Appendix: Previously Reviewed Baseline Upgrade Recommendations for the July 2021 PJM Board Review

Note: Items presented at the June 2021 TEAC & SRRTEP(s) will also be recommended for Board approval.

Changes for Existing Projects

115kV Line #81 and 230kV Lines #239 and #2056 Partial Rebuild

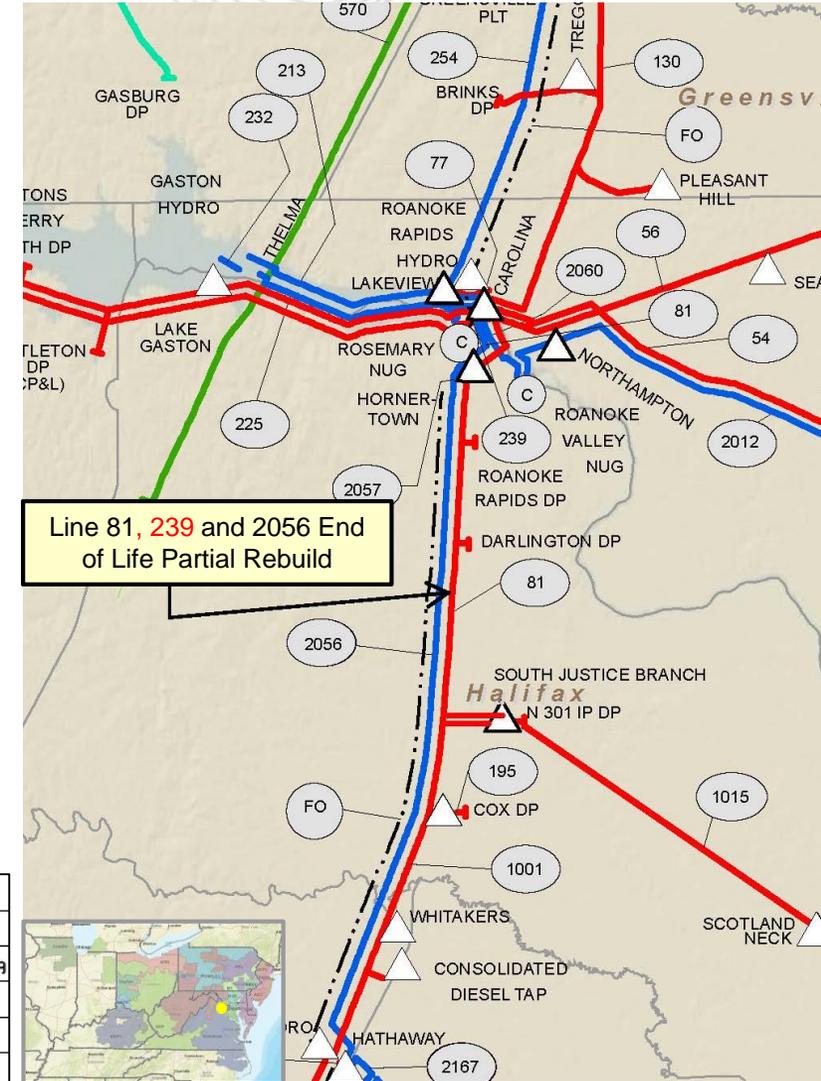
Rebuild the 18.6 mile section of 115kV Line #81 which includes 1.7 miles of double circuit Line #81 with 230kV Line #2056 and 1.3 miles of double circuit Line #81 with 230kV Line #239. This segment of Line #81 will be rebuilt to current standards with a minimum rating of 261 MVA. This segment of Line #239 will be rebuilt to current standards with a minimum rating of 1046 MVA. Line #2056 rating will not change. (b3114)

Chickahominy 230kV Breaker “SC122”, “205022”, 209122”, 210222-2”, “28722”, “H222” “21922”, “287T2129” Replacements

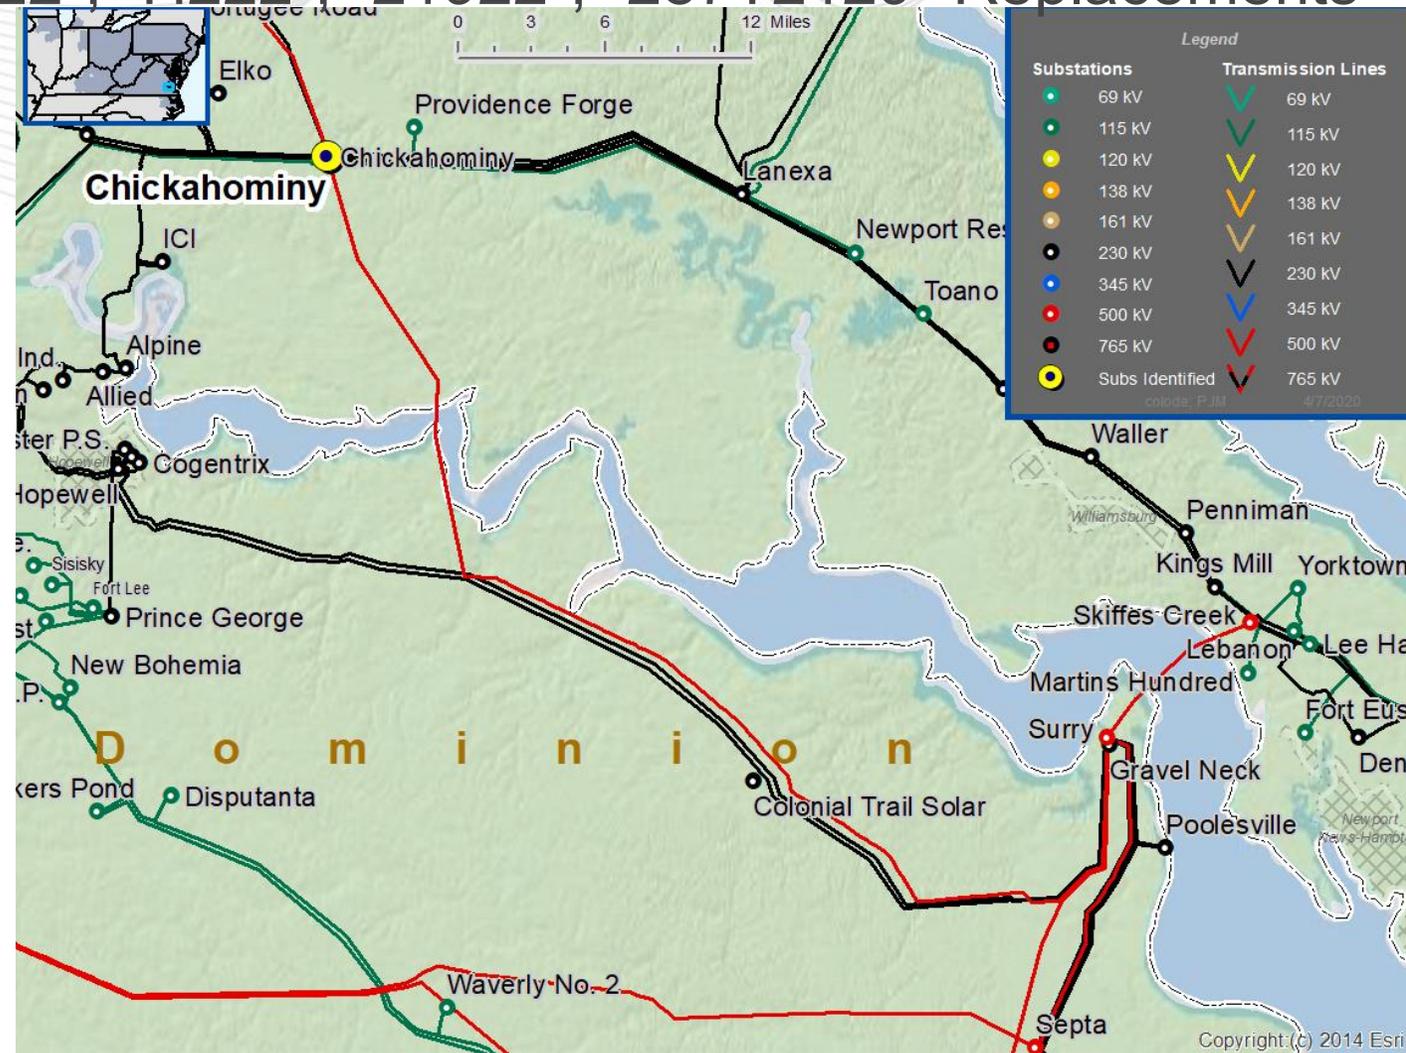
Eight (8) Chickahominy 230kV breakers are over duty: “SC122”, “205022”, 209122”, 210222-2”, “28722”, “H222”, “21922”, “287T2129”

Solution Cancellation Driver: AB2-068 Generator Withdrawn

Recommended Solution Cancellation:

b3213.1: Replace the eight (8) Chickahominy 230kV breakers with 63kA breakers: “SC122”, “205022”, 209122”, 210222-2”, “28722”, “H222”, “21922”, “287T2129”

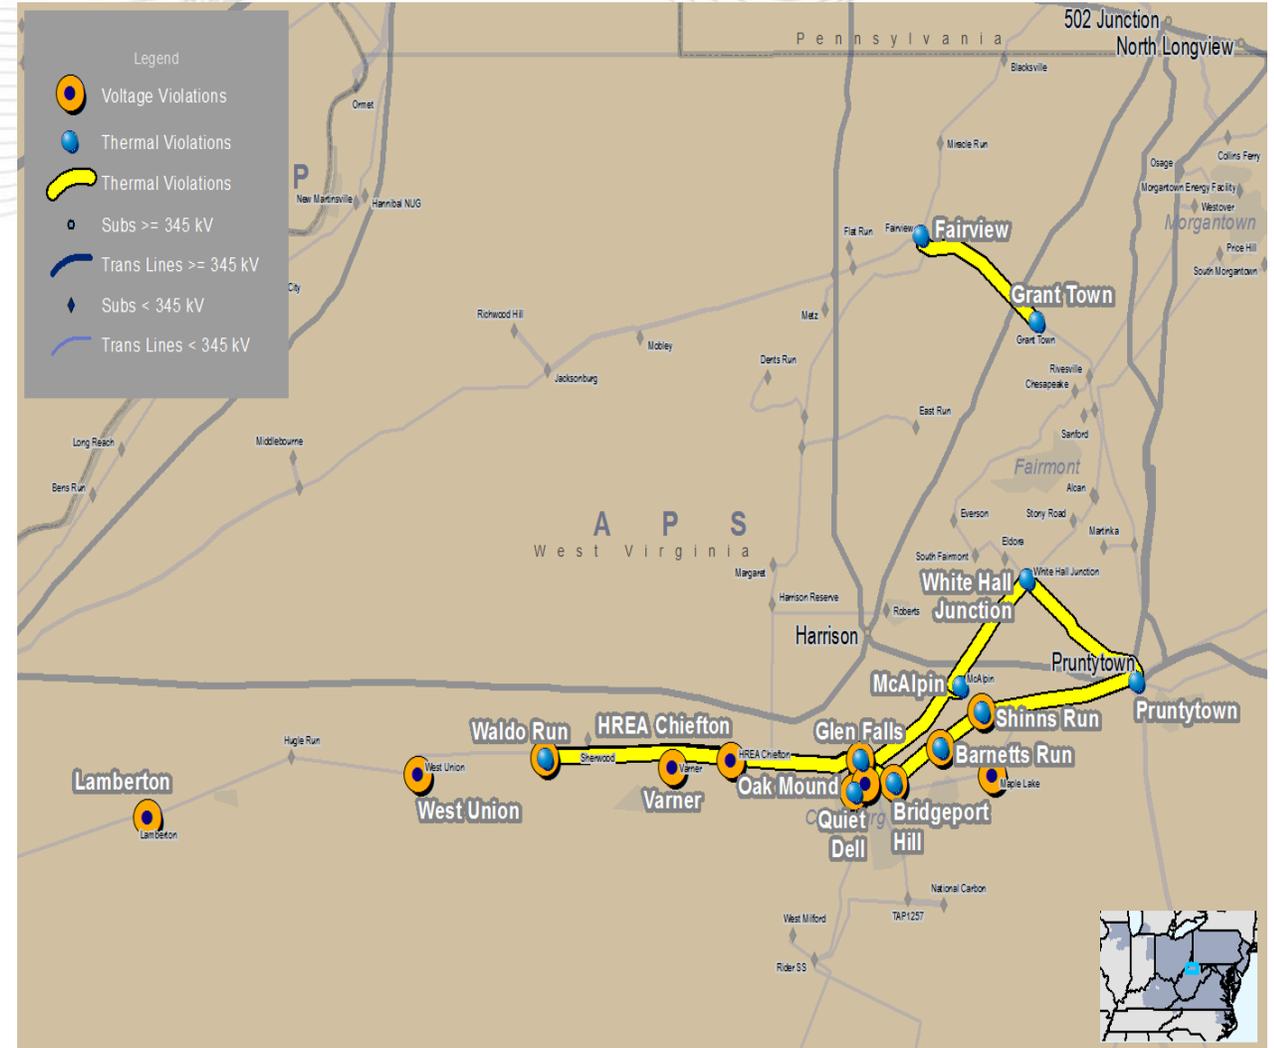
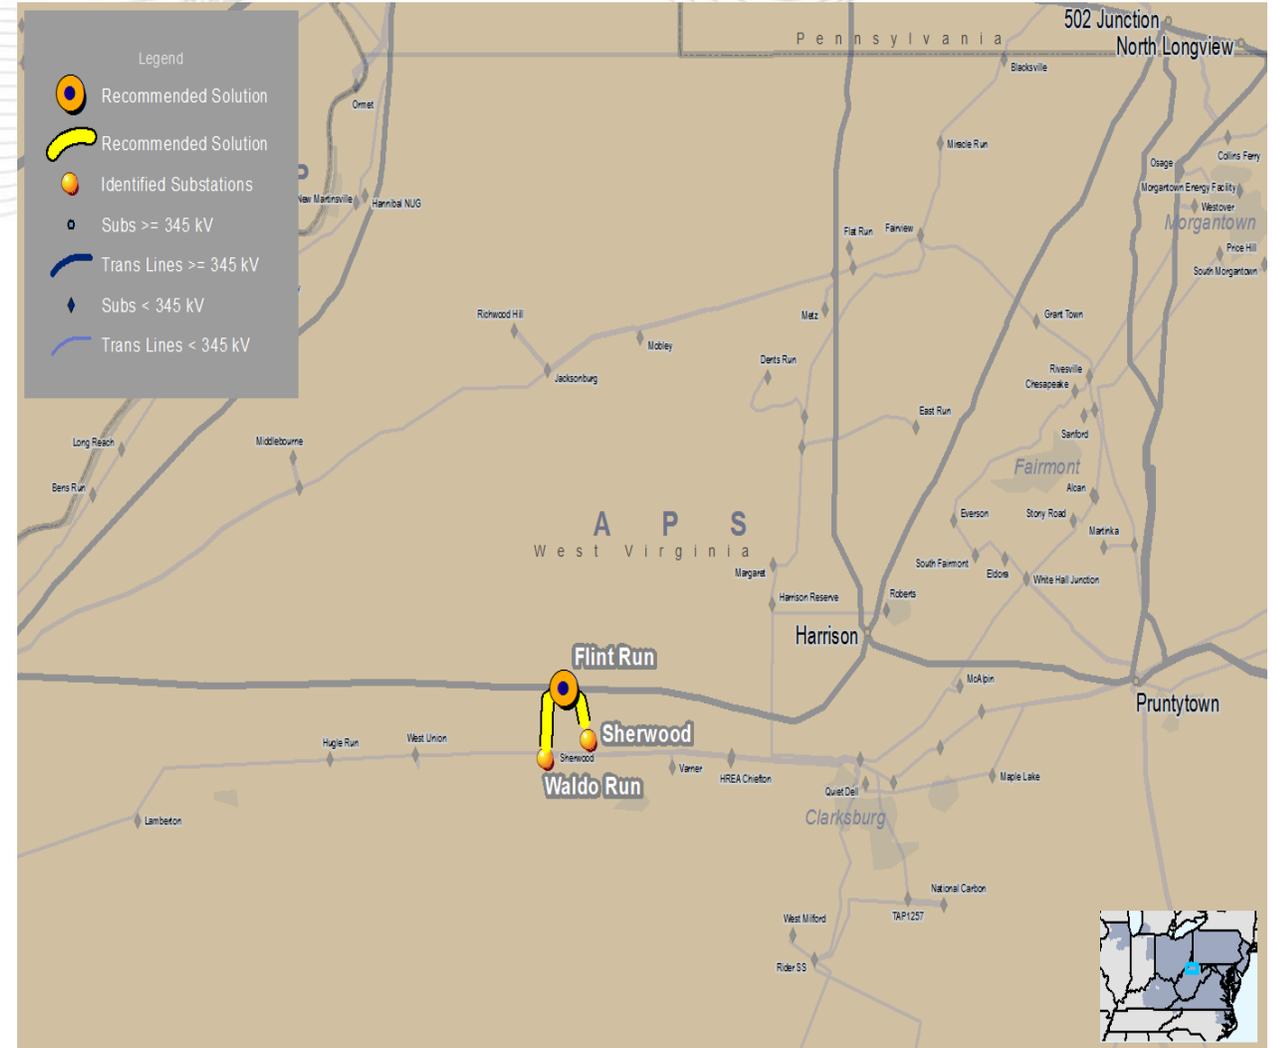
Increased customer load expectations connected to the Waldo Run 138 kV substation are causing several Gen Deliv, N-1 Thermal, and N-1 low voltage violations in the vicinity of Waldo Run, Oak Mound, Pruntytown and Fairview.

Construct a new 500/138 kV substation as a four-breaker ring bus with expansion plans for double-breaker-double-bus on the 500 kV bus and breaker-and-a-half on the 138 kV bus to provide EHV source to the Marcellus shale load growth area. Projected load growth of additional 160 MVA to current plan of 280 MVA, for a total load of 440 MVA served from Waldo Run substation. Construct additional three-breaker string at Waldo Run 138 kV bus. Relocate the Sherwood #2 138 kV line terminal to the new string. Construct two single circuit Flint Run - Waldo Run 138 kV lines using 795 ACSR (approximately **3.7 miles**). After terminal relocation on new 3-breaker string at Waldo Run, terminate new Flint Run 138 kV lines onto the two open terminals.(b2996.1) **\$125.3M**

Loop the Belmont-Harrison 500 kV line into and out of the new Flint Run 500 kV substation (less than 1 mile). Replace primary relaying and carrier sets on Belmont and Harrison 500 kV Remote End Substations.(b2996.2) **\$16.6M**

Upgrade two (2) existing 138 kV breakers (Rider 50 and #1/4 transformer breaker) at Glen Falls with 63 kA, 3000 A units. (B2996.3) **\$1.5M**

Increased cost of ~\$102M primarily due to:

- 138 kV line work increased **\$43M**
 - Design changed to steel poles
 - Line length increased 0.7 mile
 - Access roads
 - Vegetation control
- Substation location change increased **\$41M**
 - Additional civil and environmental engineering/construction
 - Real estate costs
- Other cost increases **~\$10M**
 - Retaining wall at Waldo Run Substation
 - Additional Engineering, Project Management, etc.

Terrain of 138 kV double circuit

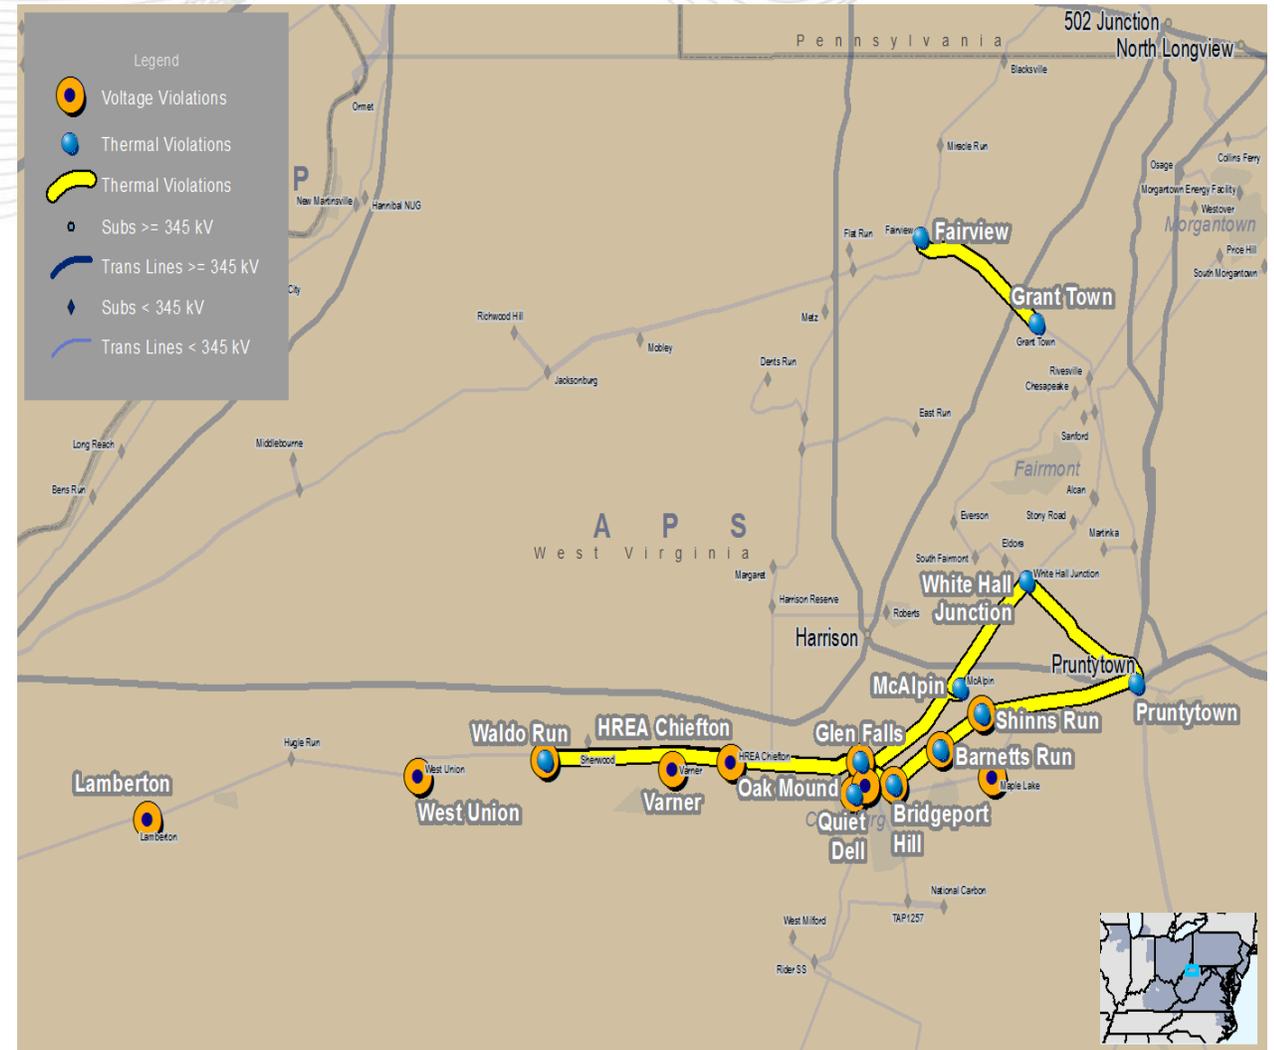
Increased cost of alternatives primarily due to:

1. Reconducting alternative was a desktop estimate. No detail from original estimate.
 - More refined estimate prepared for this update
 - Increased cost of \$104M based on present estimating information for reconducting
2. New Pruntytown-Oak Mound line increased \$156M
 - Additional reconducting project identified on double circuit 138 kV line (\$78M)
 - Access road costs (\$48M)
 - Change in line design (\$16M)

Dominion Transmission Zone: Baseline Possum Point 2nd 500-230 kV Tx

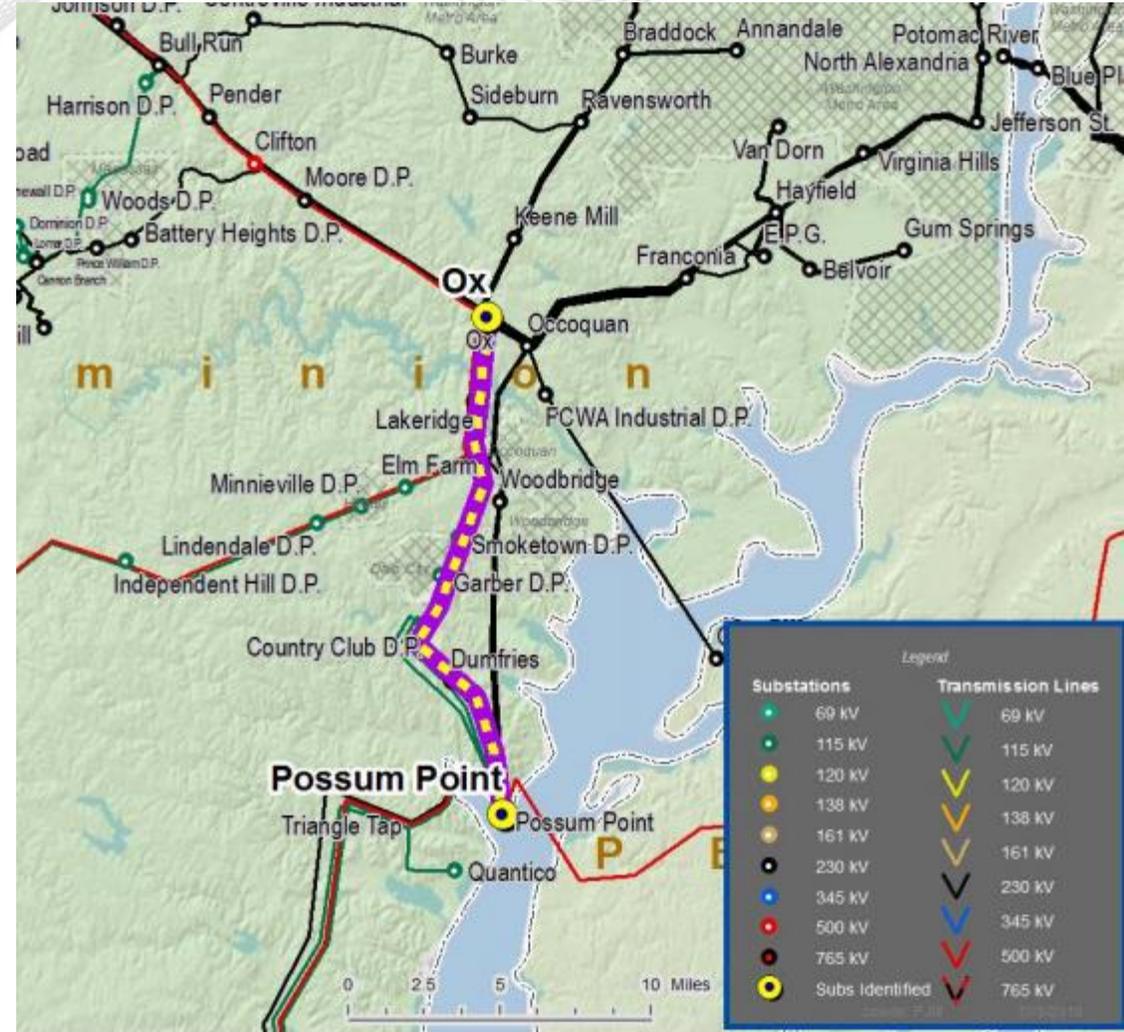
Problem Statement: Based on recent generation retirements (Possum Point Units #3 & #4) and the PJM 2018 Load Forecast updates indicates that for a NERC Category P1 – single contingency that Possum Point 500/230 kV Tx #1 overloads for a loss of the Possum Point – Ox 500 kV Line #571 under Dominion’s critical stress case criteria.

Updated criteria evaluation: Updated Summer 2023 & 2025 RTEP Models indicated deficiencies are no longer present.

Recommended Solution: Cancel the Project.

Dominion Transmission Zone: Baseline Possum Point 230kV Breaker Replacements

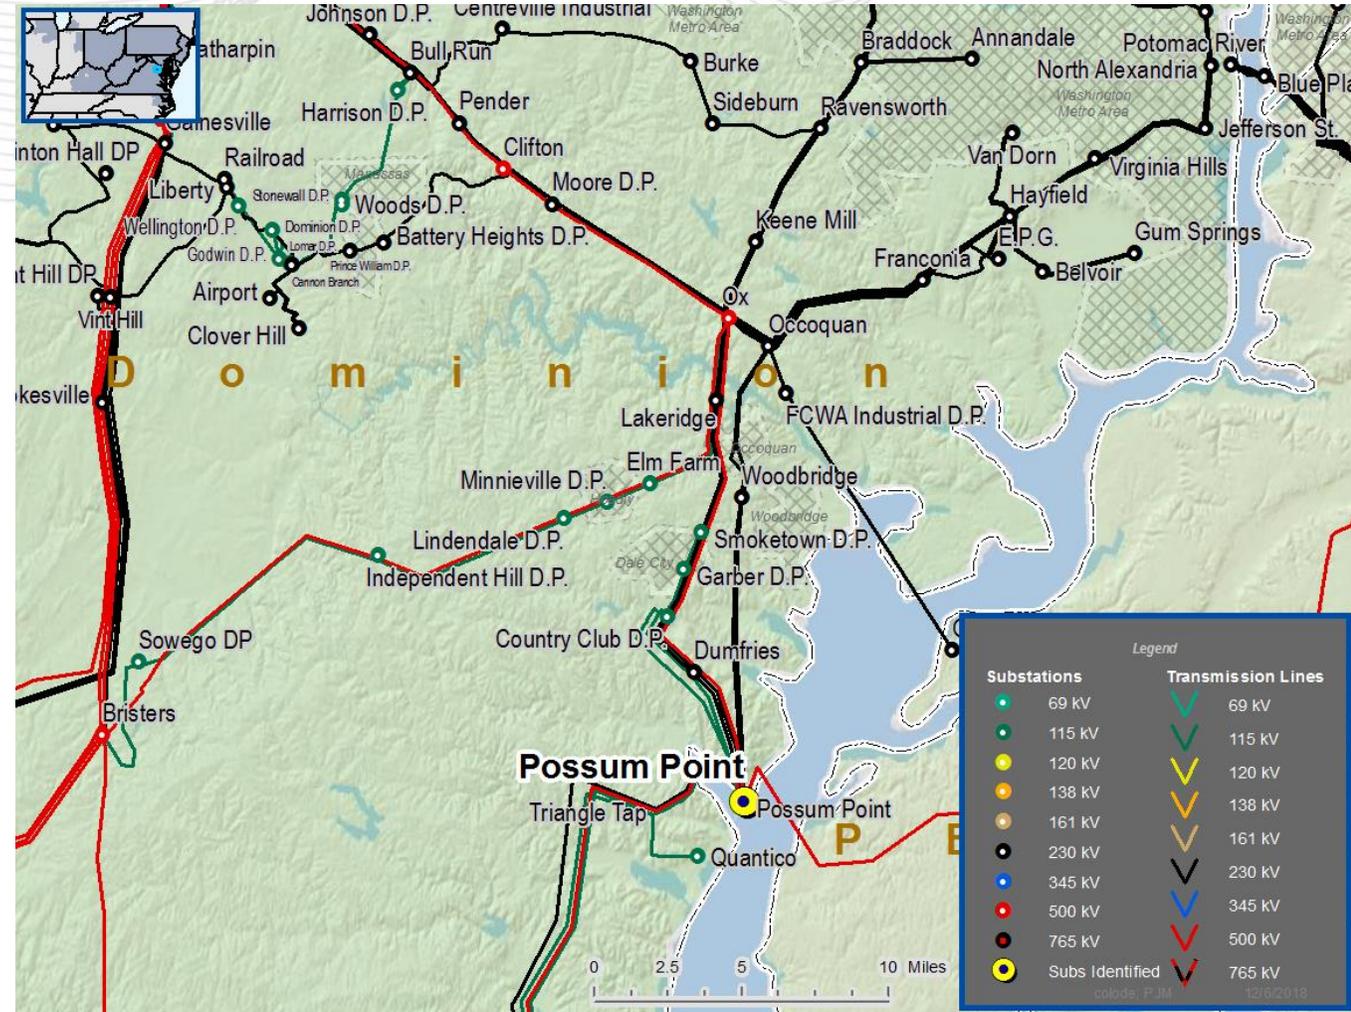
Nineteen (19) Possum Point 230kV breakers are over duty:
H892, H8T2078, H992, H9T237, 23792, G6BTGT, GT92, 202292,
252T2022, 21592, G5T215, 25292, G492, G592, G6A92, G6B92,
G4T2001, 200192, 207892

Solution Cancellation Driver: Possum Point 5 Retirement

Recommended Solution Cancellation:

b2443.7: Replace the nineteen (19) Possum Point 230kV breakers with 80kA breakers:

B2907 Cancellation

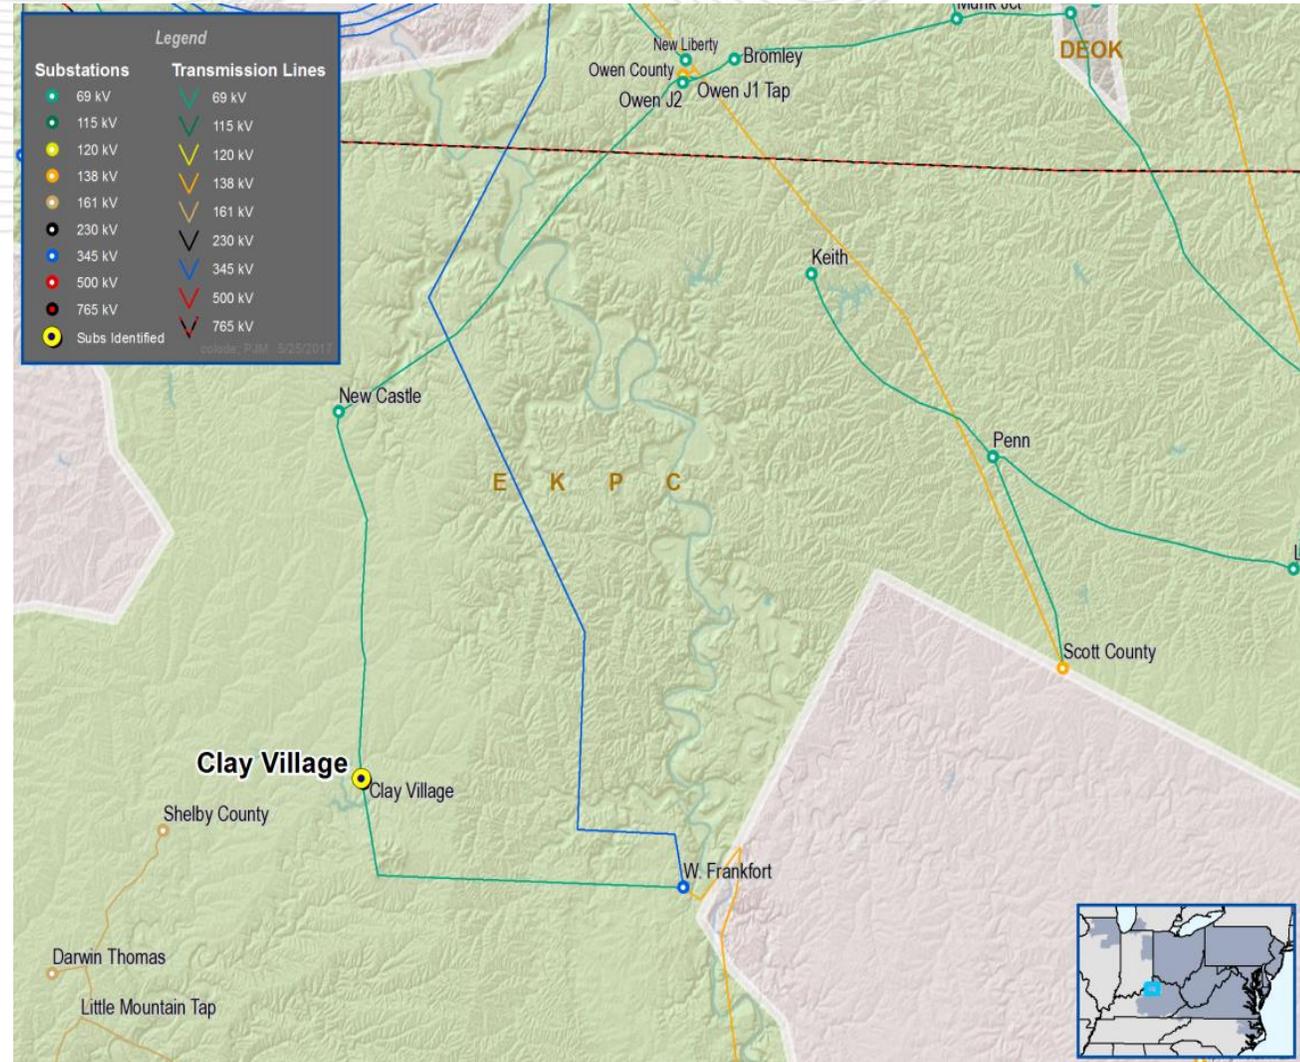
Overload of Clay Village-KU Clay Village 69 kV Tap during an N-1 outage.

The upgrade was not modeled in the 2020 RTEP case, and the same issue was identified in 2020 window. This resulted in the recommendation of baseline project b3266 (required in-service date of 12/1/2021) which has the same scope. This is an administrative update to remove the duplicate project from the RTEP.
